CALIFORNIA COASTAL COMMISSION

DATE: August 23, 2013

RE: **Pepperdine University Major LRDP Amendment No. 1-11, Part B**
(Campus Life Project – proposed final location, layout and management of recreation area, including installation of new, permanent stadium-type sports lights for future playing field in Marie Canyon); scheduled for Commission hearing and action at the September 11, 2013 meeting, in Eureka.

Exhibit 6
Profile View of Enhanced Recreation
Area and Proposed Field Lighting
LRDP Amendment 1-11, Part B
Pepperdine University

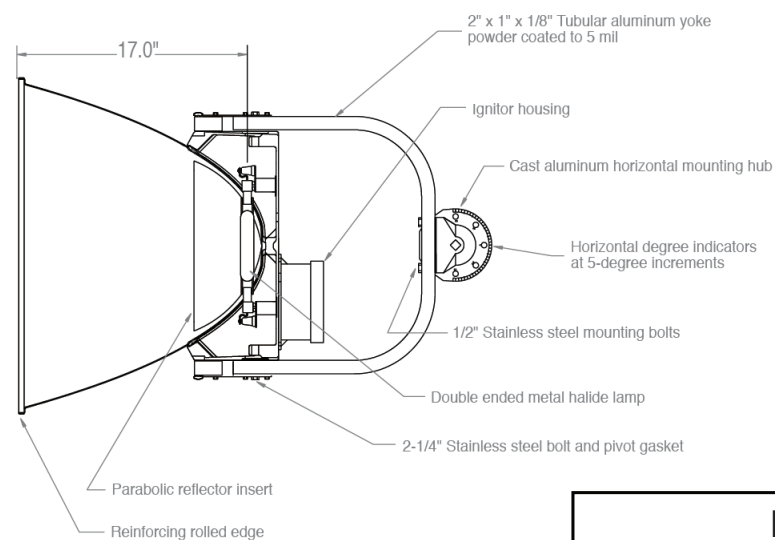
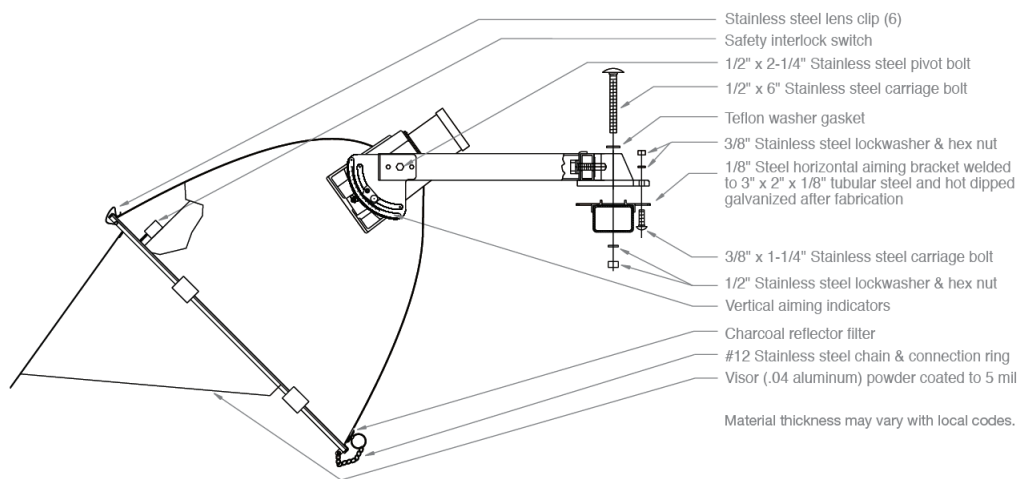
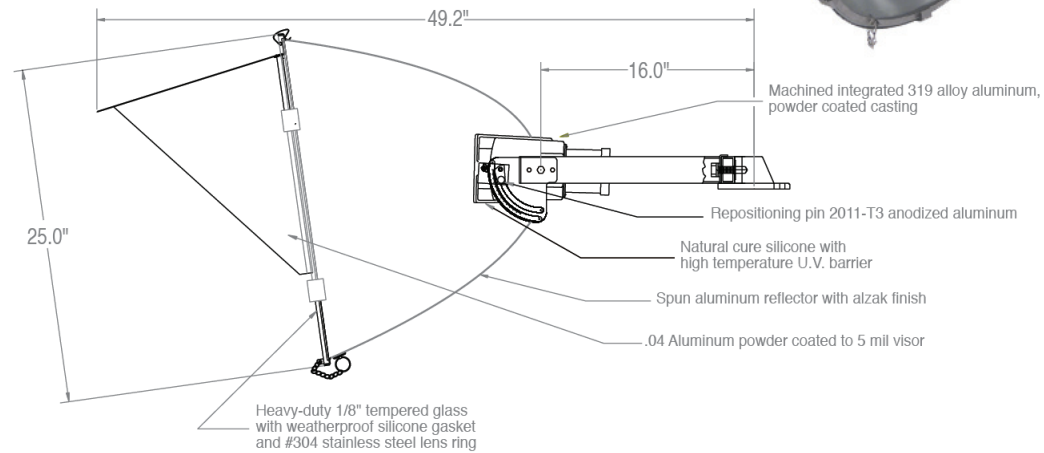
The proposed lights would be installed atop a fill pad supporting the playing field authorized pursuant to Part A of LRDP Amendment 1-11, at a finished elevation (the maximum elevation authorized for the pad surface) 565 feet above sea level. The proposed (Part B) lights mounted on 80-ft. high poles would therefore extend vertically to the 645-foot elevation-equivalent. The lights would provide for night use of the authorized 240-ft. by 340-ft. playing field. The University states that the Marie Canyon playing field would only be used for recreational intramural and club sports, and that the fixtures and lights proposed for the Marie Canyon field would not be adjustable or adaptable to the higher power settings necessary for collegiate-competition sports use, such as NCAA games, televised games, or practices. This amendment will also allow for the final siting of a new 1,600 sq. ft. restroom/storage building authorized in Part A that was conceptually located southeast of the authorized playing field.

Although the Marie Canyon playing field is located in a canyon at the northern periphery of the developed campus and is partially shielded by steep slopes, the playing field lights would be located at a topographic elevation several hundred feet higher than the lower campus elevation (see the Figures attached to the memorandum of Commission staff ecologist Jonna Engel, included in Exhibit 12, which show among other things, the Marie Canyon site in oblique aerial view perspective of the site). North of the subject site, publicly used trail corridors are located at higher elevations with views downward toward the subject Marie Canyon location hundreds of feet down gradient. The Marie Canyon field lights would be readily visible at night from at least five viewing areas along the portion of the combined Mesa Peak and Coastal Slope public trail route that traverses the northern campus above Marie Canyon (Exhibit 8).

Staff Recommendation: Staff is recommending that the Commission approve Long Range Development Plan (LRDP) Amendment 1-11-B to the certified Pepperdine LRDP with two suggested modifications, which would prohibit lighting of the approved recreational field in Marie Canyon and require the submission of a Recreation Area Management Plan. For the reasons summarized below, staff does not support the University’s proposal to install the proposed playing field lights at the Marie Canyon playing field.

(1) The Recreation Area in Marie Canyon shall be limited to day use, and no night lighting, whether temporary or permanent, shall be installed.

Figure 10. Receptor site locations. Figure 4 from Krahe & Assoc. Inc. Lighting Analysis.

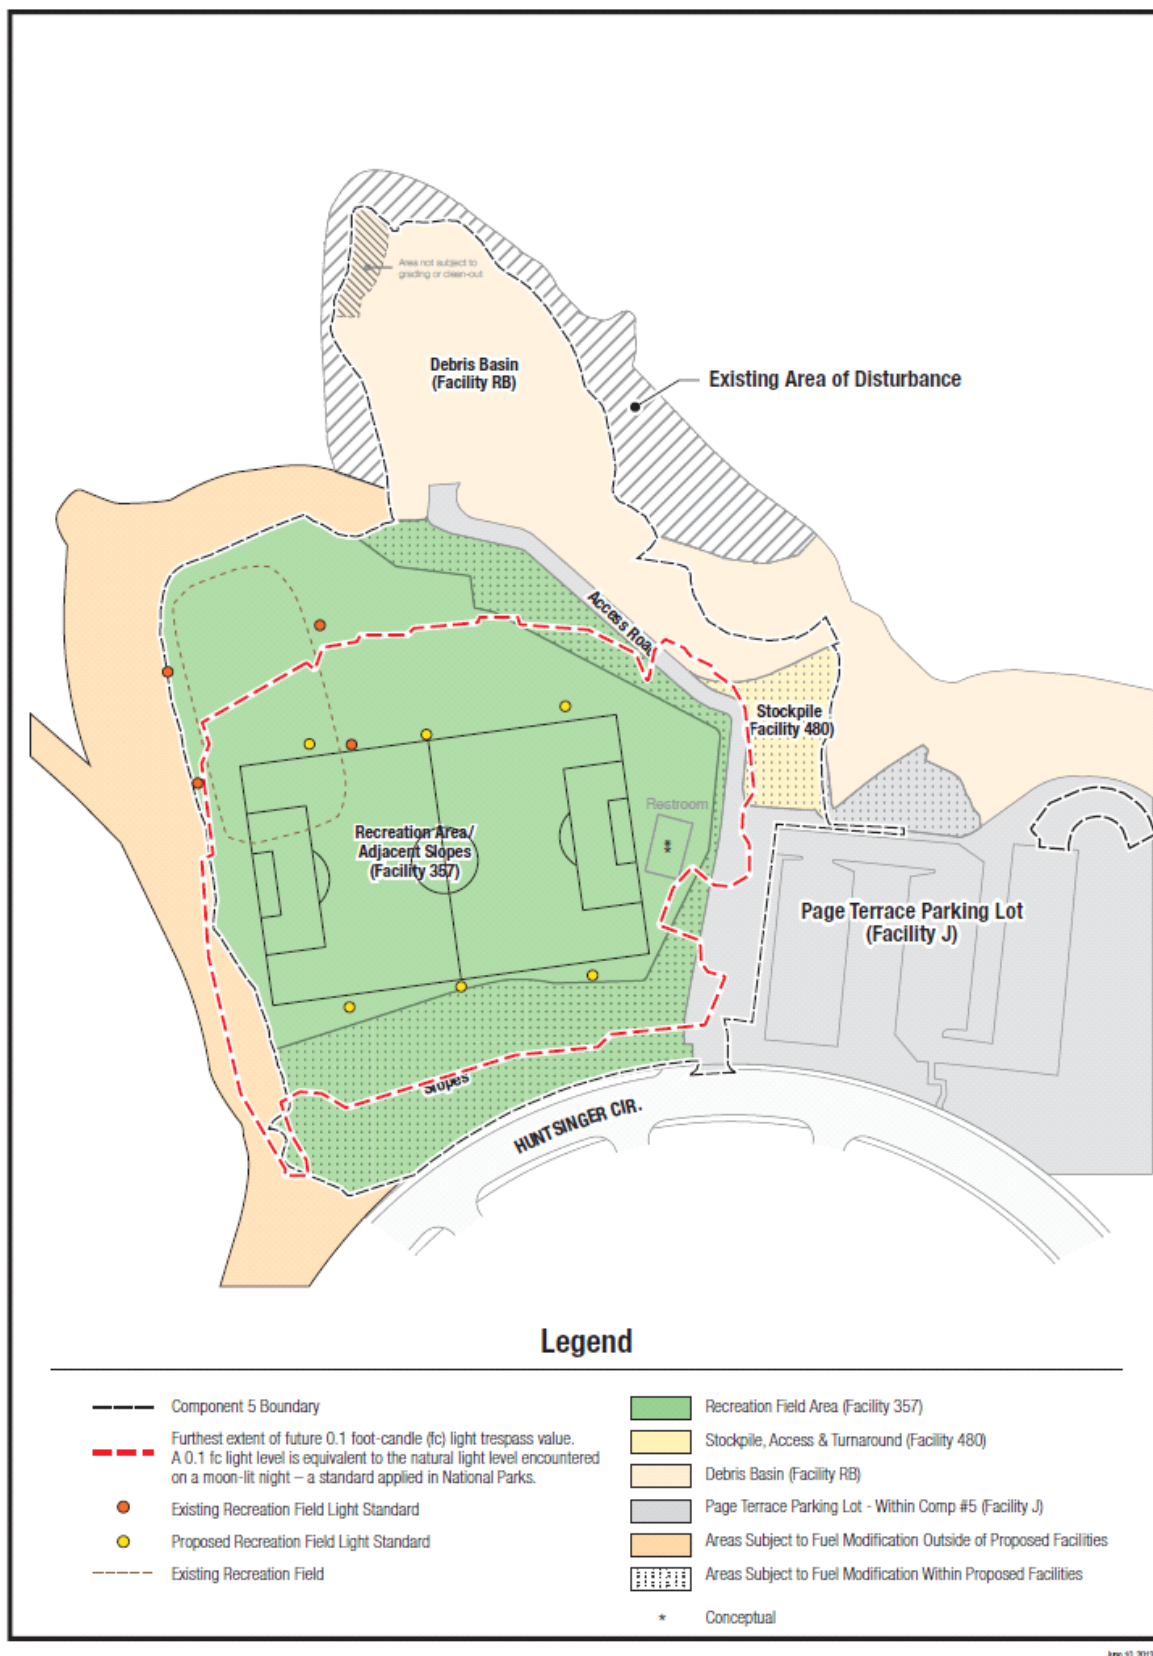
Krahe & Assoc. set up seven receptor sites (D, E, F, G, P, R, & S) on and around the Component 5 site to measure the illuminance and luminance of the existing lights and to model the expected values for the proposed lights (Figure 10). Their analysis assumes that the new artificial night lights at the new intramural field at the Component 5 site will create a significant impact only if they create light trespass greater than 0.1 fc into the natural areas surrounding the field. They provide no review, analysis, or basis for the 0.1 fc criteria in terms of impacts to wildlife. Instead, the value is stated to be an industry standard and is left at that. Figures 11 and 12 show the 0.1 fc threshold line (dashed red line) around the new intramural field in the east-west and north-south orientations, respectively. The 0.1 fc threshold extends minimally beyond the intramural field pad. However, illumination values for light trespass between 0.1 and 0.001 fc extend well into the ESHA surrounding Component 5³⁵. Krahe and Assoc. light modeling of the proposed lights show light trespass values equivalent to brighter than moonlight emanating into the surrounding ESHA only decreasing to values equivalent to a clear starry night high on the surrounding slopes³⁶. We believe that illumination in this range does pose significant adverse impacts to animals inhabiting the ESHA for the reasons discussed above and below.

In addition to Krahe and Assoc.'s lighting report lacking analysis specific to light impacts upon wildlife, the report also does not evaluate the unique location and topography of Component 5³⁹. Night lights in this location push negative impacts associated with development and human activities farther into pristine habitat. The Component 5 area and surroundings are very dark at night. Photos of the Component 5 site taken from receptor site locations D, E, and G demonstrate the dark nature of the surrounding area (Figure 13). In our view, regardless of the exact contrast values, the proposed artificial night lights at the Component 5 site will create a large dome of light highly visible to the wildlife inhabiting the immediate slopes around the new intramural field and the greater Marie Canyon watershed area that will disrupt, deter, and disturb their natural behavior and activities. Given the topography of the area, all views of the lighted field from the adjacent habitat will be either looking down or straight-on to the dome of light. This dome of light, especially under inclement conditions, would be the defining feature at night in the Marie Canyon watershed. The effects of night lighting on wildlife are not limited to shining light into the habitat; the effects include the sheer presence of the light. Based on the location of the Component 5 site and our knowledge of the light sensitivity of animals, we find that artificial night lighting at the new intramural field will adversely impact wildlife that occupy ESHA.

We recommend that the recreational amenities proposed for Component 5 be limited to day use only. Contingent to this recommendation, either field orientation is acceptable; east-west or north-south. Finally, we support the proposed location of the restroom and storage facility between the field and parking lot because it will not require additional fuel modification and reduces noise impacts and other disturbance to the surrounding ESHA.

Figure 13. Photographs from three receptor site (D, E and G) views around the Component 5 site illustrating the dark nature of the surroundings.

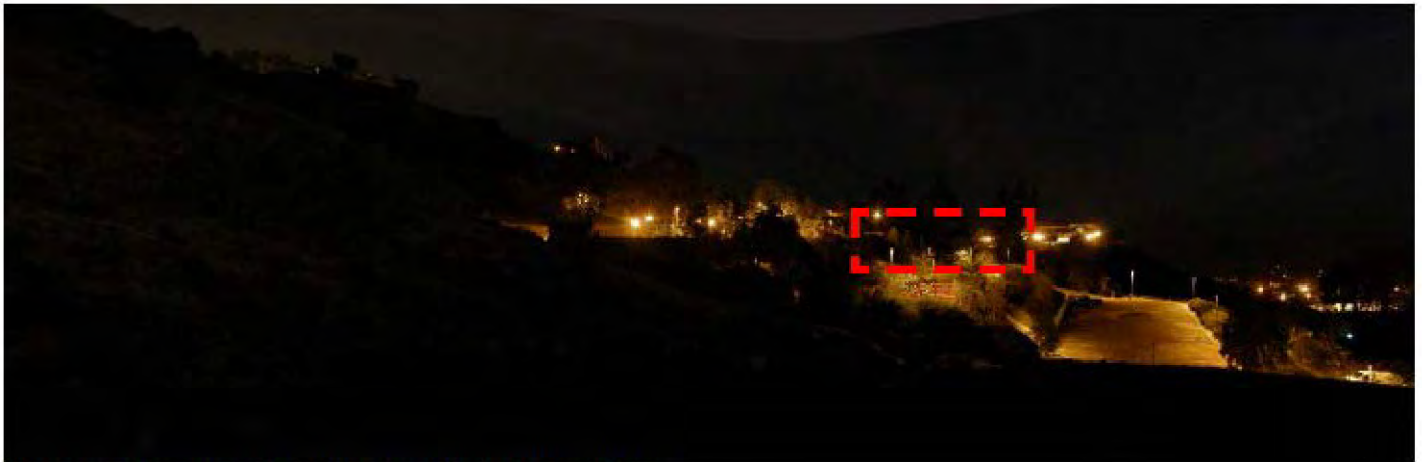
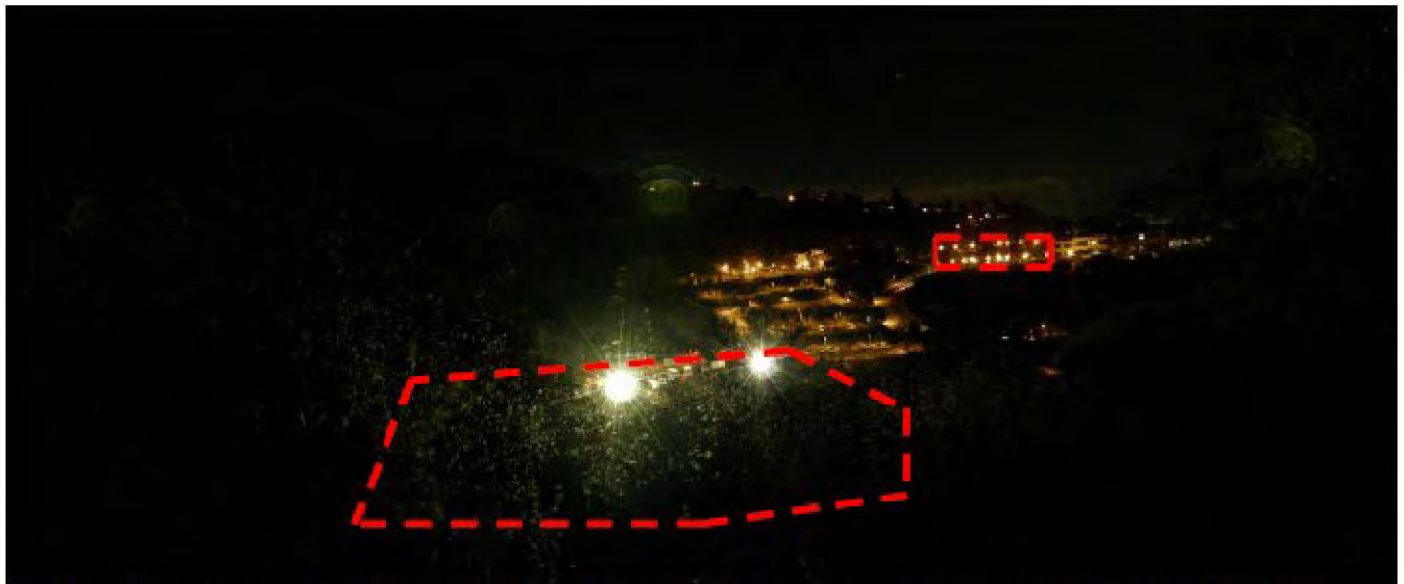
It is the unique position and surroundings of the Component 5 site that set it apart from the other sports fields on Pepperdine University campus. The Component 5 site is positioned in a bowl or amphitheatre against the slopes of the Santa Monica Mountains at the apex and northern-most edge of the developed campus; at the urban-rural (artificial light-natural light) boundary (Figure 3). The slopes surrounding the Component 5 site support native habitat that rises to the level of ESHA that in turn supports numerous native animals. Because of its topographical setting the Component 5 site is actually more isolated than a plan-view map would suggest. Animals within and around the Component 5 site, especially at night, experience the area generally as an uninhabited and natural area suitable for conducting animal business as usual.
